Bulletin No.: PIT5538

Service Bulletin

Subject: Park Brake Lever Contacts Rear Hub Flange After Rear Wheel Bearing Replacement

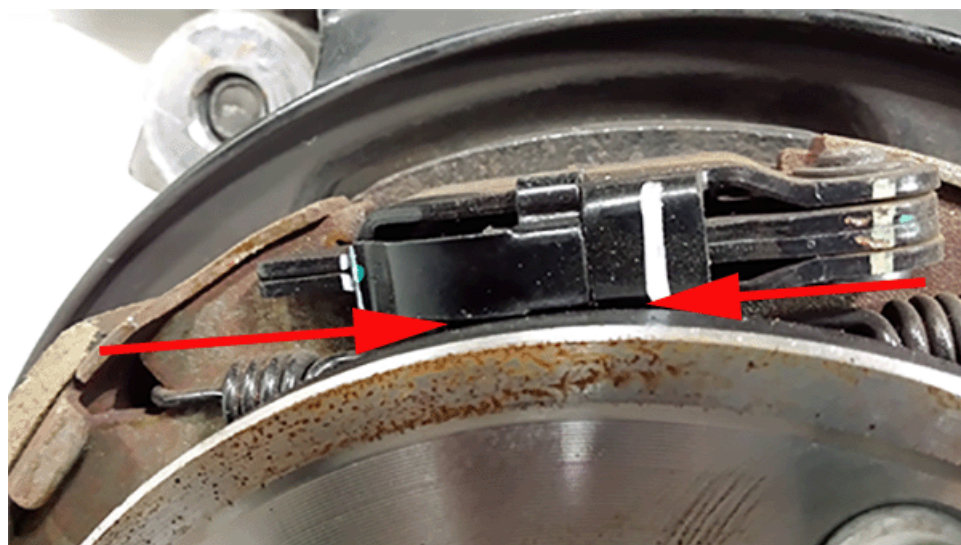
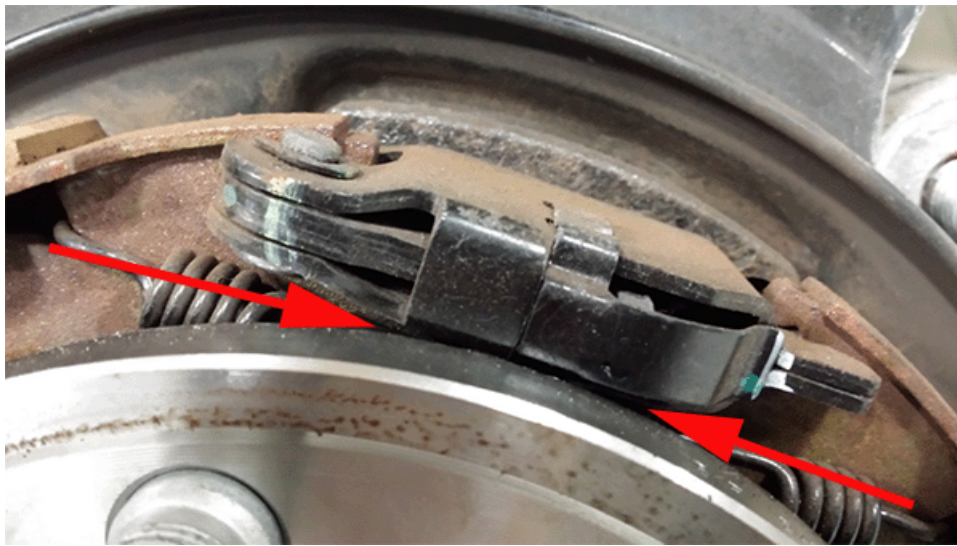
| Condition | Park brake lever contacts rear hub flange after rear bearing replacement. |
| Cause | Replacement Rear Bearing assemblies have a thicker hub flange that can cause an interference between the hub flange and park brake lever. |

Showing incorrect gap

Loosen park brake lever and move lever away from flange enough to create a gap

Showing corrected gap
